Reg. No. H0223-01

Re: Digby Bridge Landfill – Notice in accordance with Regulation 7(4) of the Waste Management (Certification of Historic Unlicensed Waste Disposal and Recovery Activity) Regulations, 2008

Please see responses below numbered as per your original request for information.

Encl. FIGURE 2A: MADE GROUND & WASTE BOUNDARIES WITH EXISTING & PROPOSED ONSITE MONITORING LOCATIONS

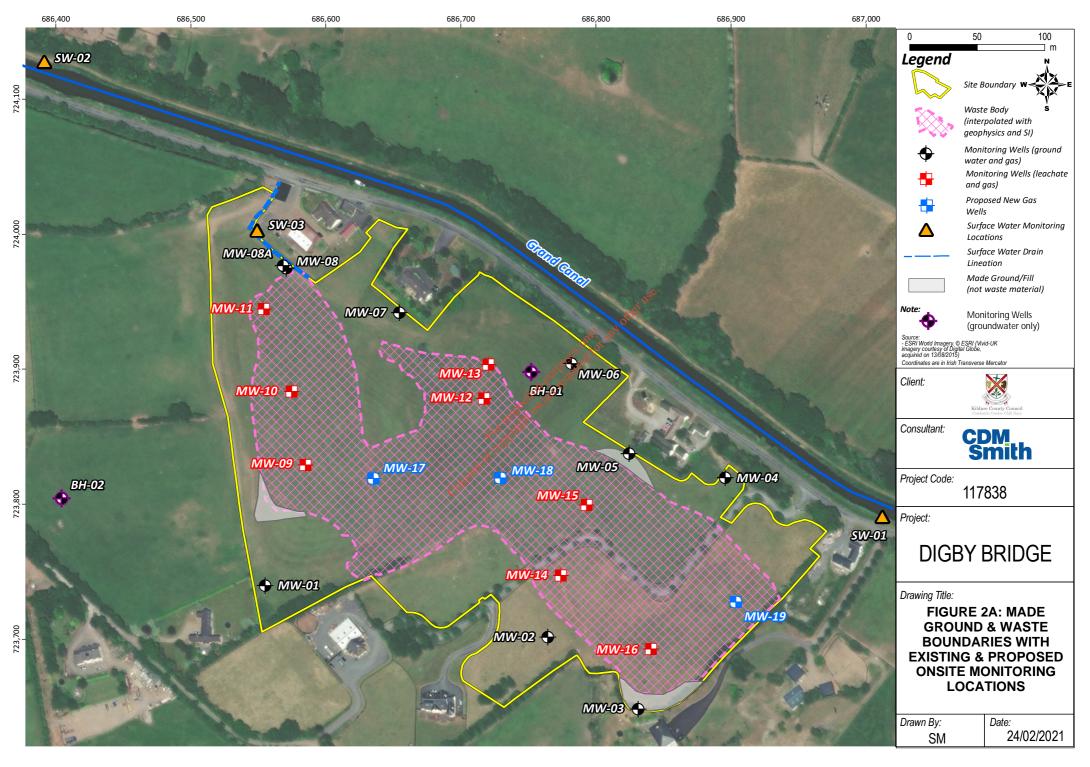
- 5. Please see 'Figure 2A: Made Ground & Waste Boundaries with Existing & Proposed Onsite Monitoring Locations'. This shows the extent of the waste body with the following elements interpolated:

- (i) the extent of "Made Ground/ Fill (not waste material)" referred to in Section 3.2.2 of the Tier 2 Assessment;
 - (ii) the existing and proposed monitoring locations for gas, leachate, groundwater and surface water (note SW-03 is included but it was not sampled as it was found to be dry on all sampling rounds). There are also proposed additional offsite groundwater monitoring locations shown in the Remediation Plan, on 'Figure 3: Groundwater Remedial Plan'; and,

- (iii) the site boundary around the entire site.
- 6. The only ditch that was discovered in the Site Investigation, as described in the Tier 3 Assessment, Volume 2 Section 2.3 was: A shallow drainage ditch is present at the north-western margin of the site alongside a single farmyard and dug to divert surface runoff from the landfill away from the farmyard. The only discharge evident was an overflow from the ditch onto the adjacent road was witnessed, where it pooled. 'Figure 2A: Made Ground & Waste Boundaries with Existing & Proposed Onsite Monitoring Locations' shows the location of this ditch.
